RE: SUMMIT COUNTY
SUMMIT LAKE BASIN
CITY OF AKRON
DR THOMAS MC EBRIGHT
COMMUNITY LEARNING CENTER

RE: McEbright Community Learning Center
Response Letter for June 17th Inspection

Figure 2. No inlet protection was observed on most of the site's storm sewer inlets.

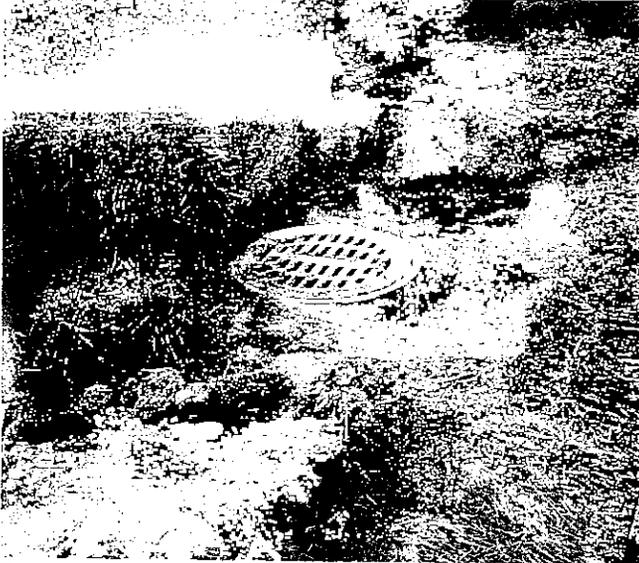
- No or improper inlet protection has been installed throughout the site. Mr. Simonetta stated that it is not possible to install the inlet protection as called for in the site's SWP3 due to the fact that many of the storm sewer inlets are located in the construction access roads. It was also noted that some of the storm sewer inlets were buried beneath at least a foot of stone. A revision will need to be made to the site's SWP3 to provide adequate inlet protection.

Filter fabric was wrapped around the grates and then set into the catch basin before the stone drive was installed. Based on a conversation between Paul Schmoll and Sean Green, this method is acceptable and revised drawings are not required.
